**ARIZONA NUCLEAR POWER PROJECT**  
**PALO VERDE NUCLEAR GENERATING STATION**

**ELEMENTARY DIAGRAM**  
**SAFETY INJECTION & SHUTDOWN CLG SYSTEM**  
**SPRAY CHEMICAL ADDITION PUMPS**  
**M-SIA-POS & M-SIB-POS**

SCALE NONE	JOB NO. 10407	DRAWING NO. 13-E-SIB-036	REV. 3
------------	---------------	--------------------------	--------

**PALO VERDE NUCLEAR GENERATING STATION UNITS 1, 2 & 3**  
**DRAWING CHANGE NOTICE (DCN)**  
 JOB NO. 10407

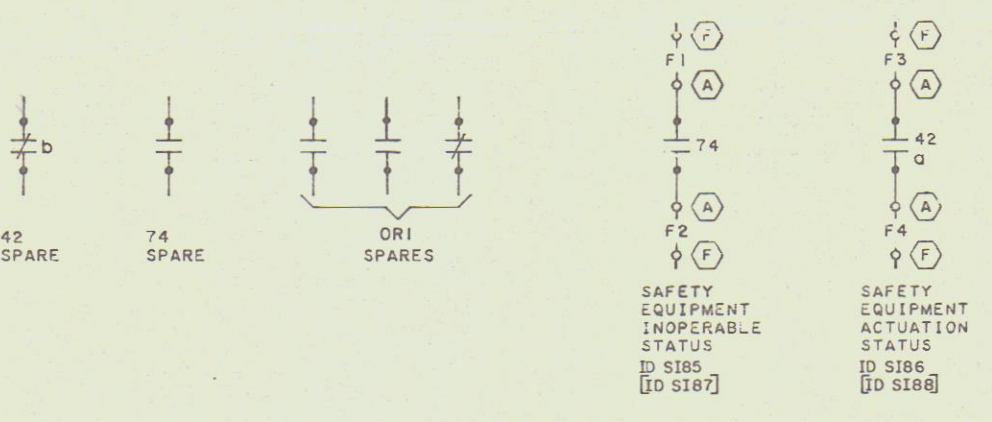
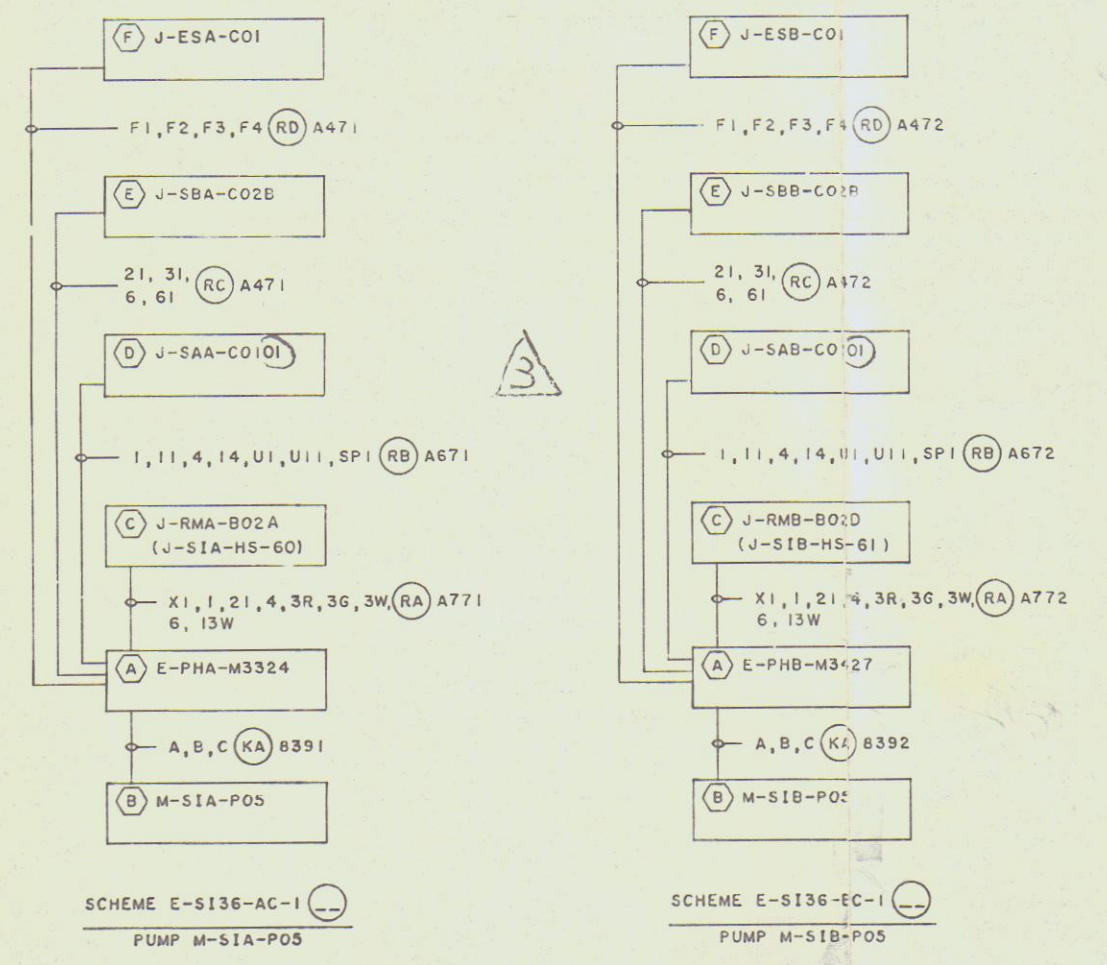
DESCRIPTION OF CHANGE: CHANGE START-STOP CONTROL CIRCUIT PER THE FOLLOWING:

**WAS:**

**IS:**

**AFFECTED EQUIPMENT:**

MCC: E-PHA-M3324 AND  
E-PHB-M3427
